CITY PLAN COMMISSION REPORT

Cathedral of the Immaculate Conception

04 CD-CPC-2021-00239
 Development Plan

A request to approve a development plan to remodel and expand a religious assembly and its accessory uses in District DC-15 (Downtown Core dash 15) on about 1.613 acres, generally located on the west side of Broadway, in between W. 11th Street to the north and W. 12th Street to the south.

C201

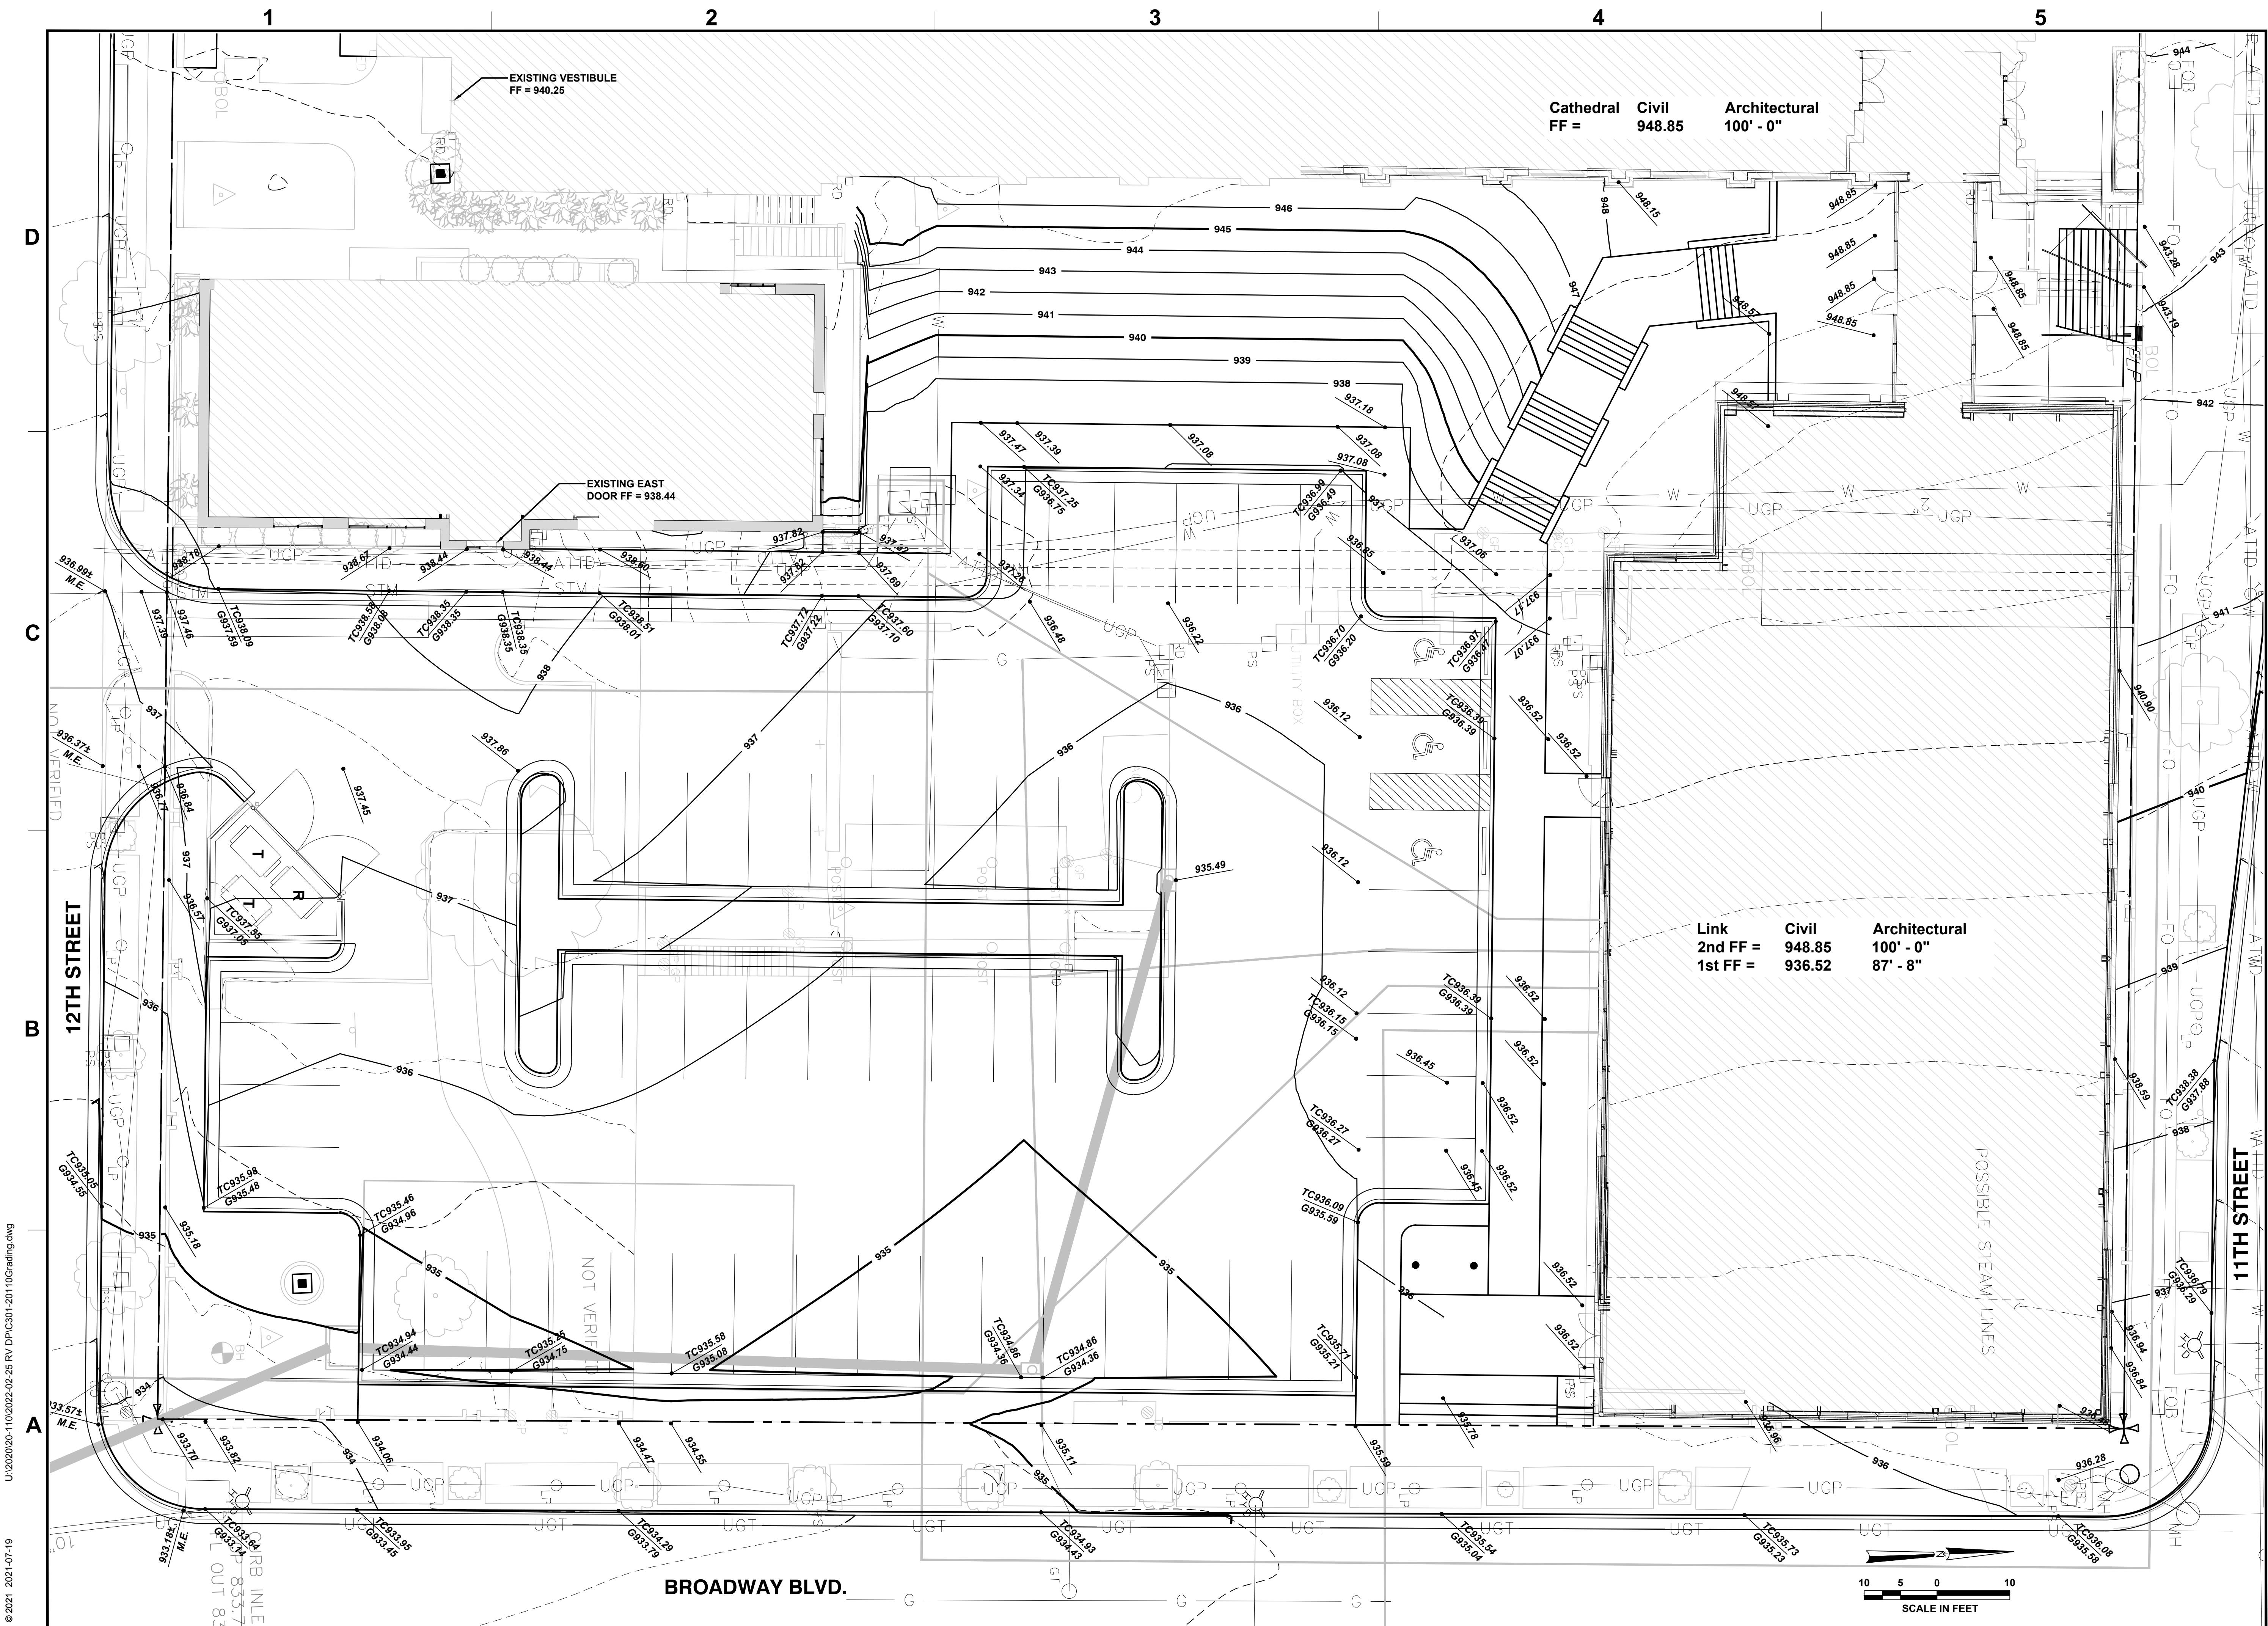
The applicant proposed Variance Request (A): A 26-foot variance to the minimum setback of 30 feet for a vehicular use area located on the side or rear of the building, for a total setback of 4 feet. This variance was granted by the Board of Zoning Adjustment on March 8, 2022 through Case No. CD-BZA-2022-00014.

Even though DC (Downtown Core) District does NOT require any parking spaces, the applicant is proposing 52 parking spaces through a reconfigured parking lot by Broadway located to the south of the new building addition. Staff doesn't adore this site layout, but with the variances been granted, the design generally complies with the code.

The proposed reconfiguration of the parking lot would eliminate two of the three driveways; the only driveway would be located on the south side of the property along W. 12th Street. Staff believes the reduction of curb cuts will improve a safer vehicular circulation.

23. Label the driveway width and radii. (2/01/2022)

1 CITY EXTERIOR ELEVATION - PARISH CENTER - EAST
A202 1/8" = 1'-0"

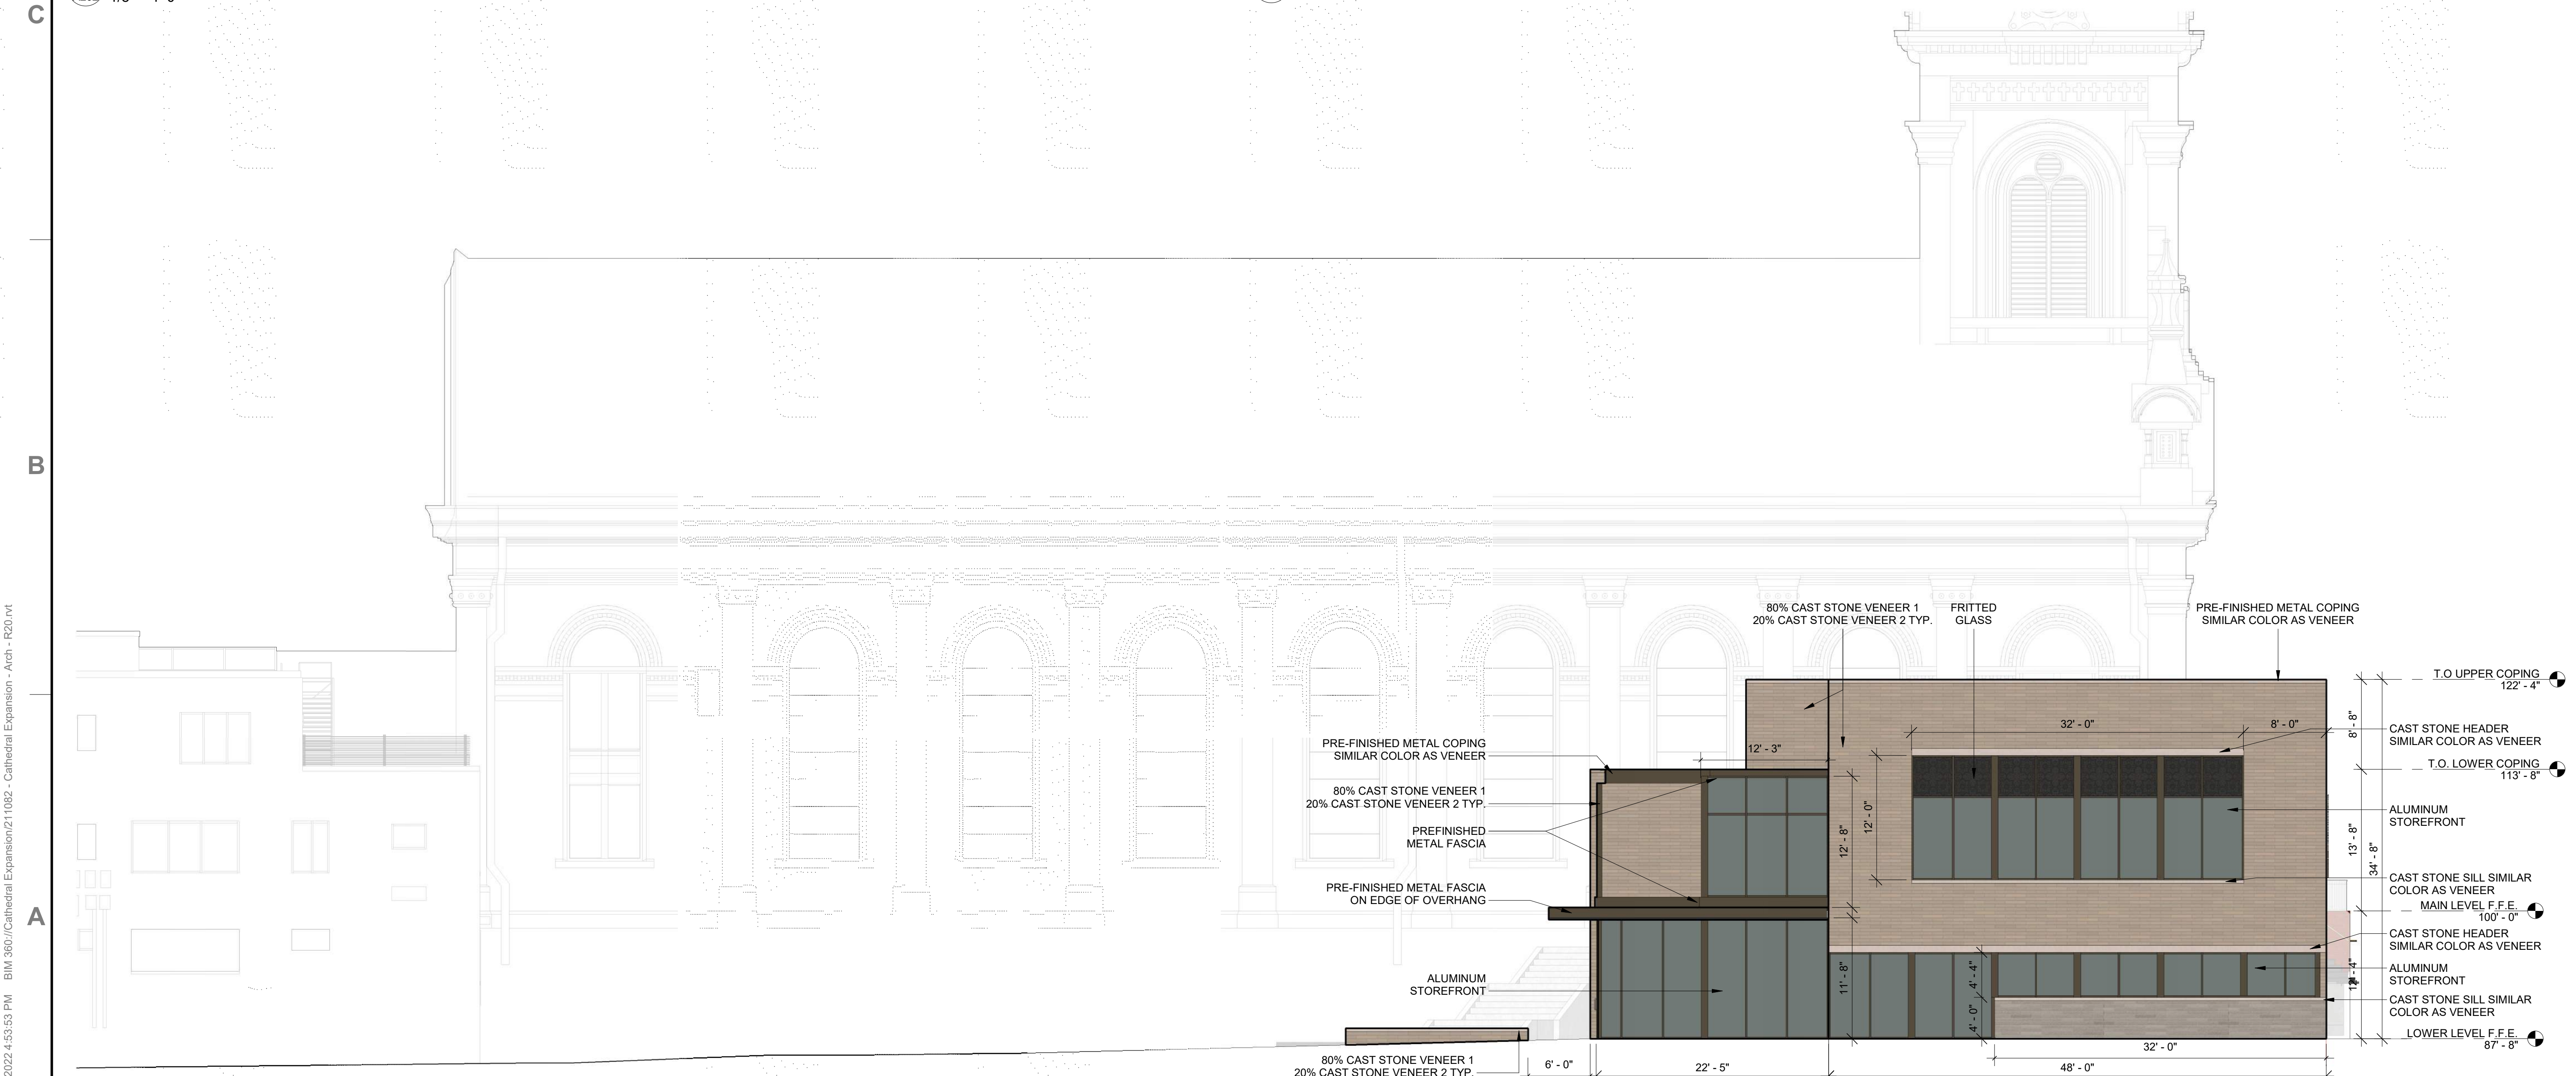
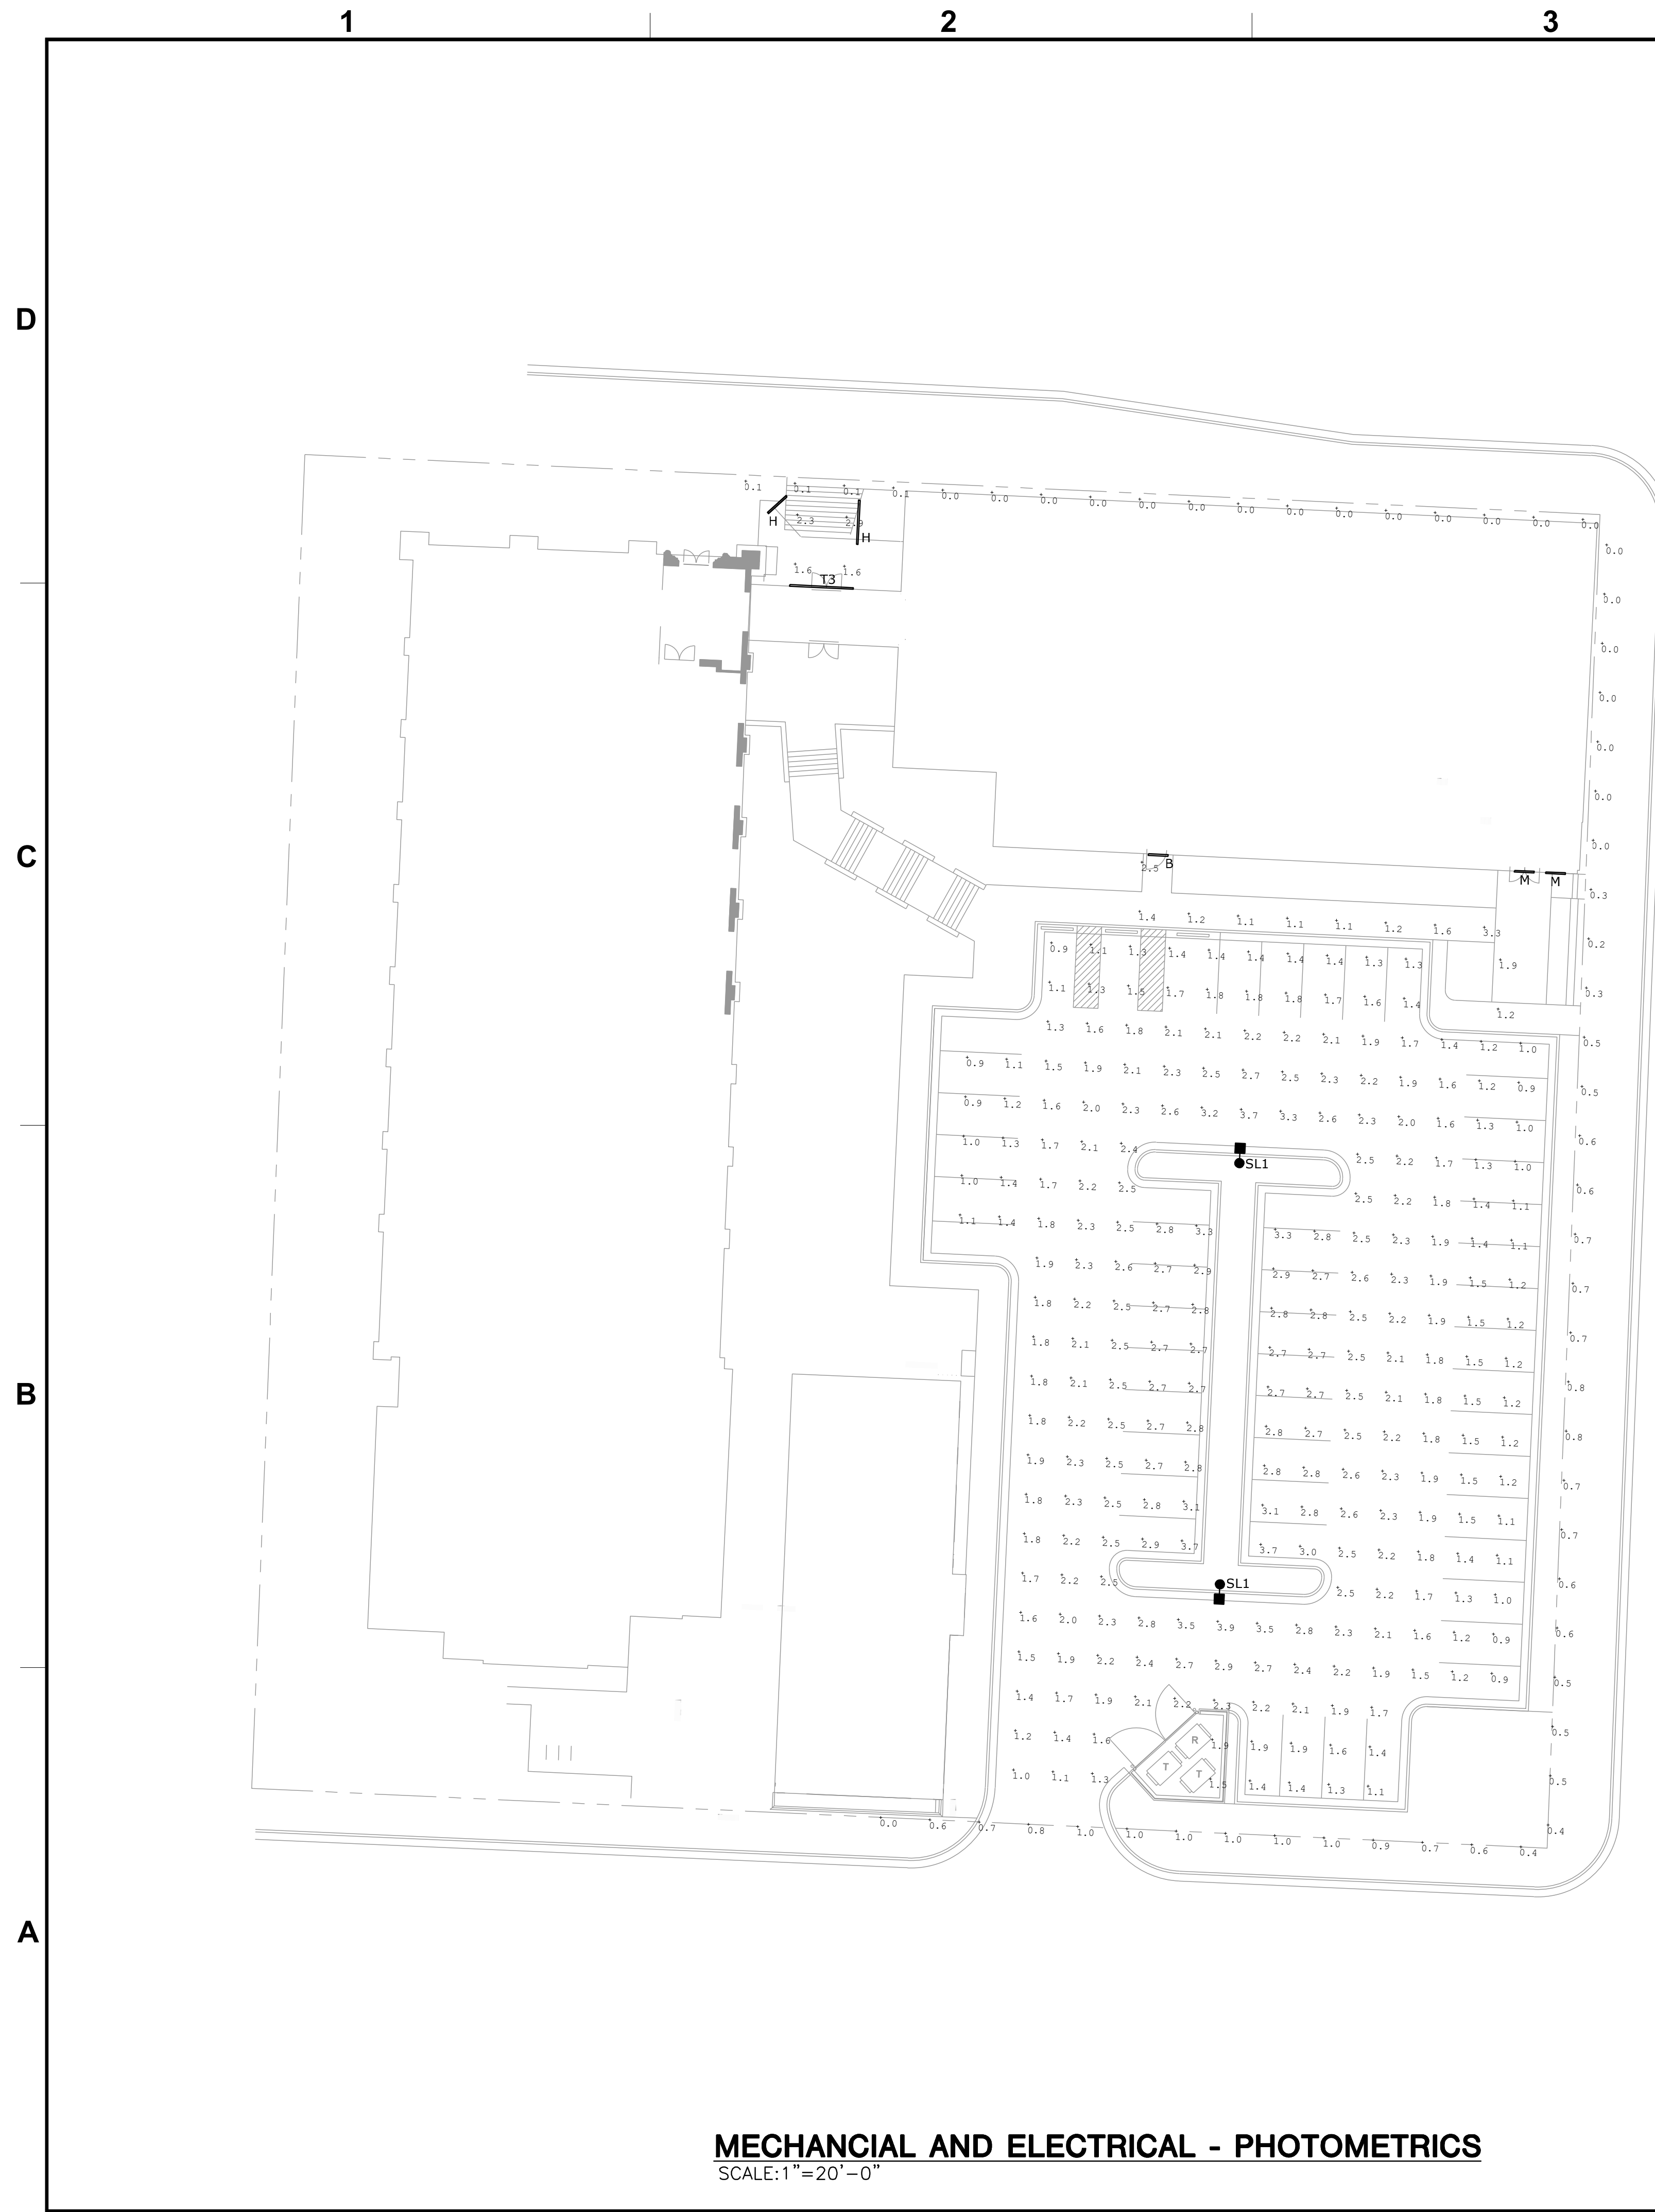
The proposed elevations indicate a beige and earth tone color for the proposed addition. A major of the building materials on the façade will be cast stone veneer and fritted glass with accent materials made of aluminum and prefinished metal. The proposed east elevation facing Broadway has a transparency of 61%, which complies with the Boulevard and Parkway Standards.
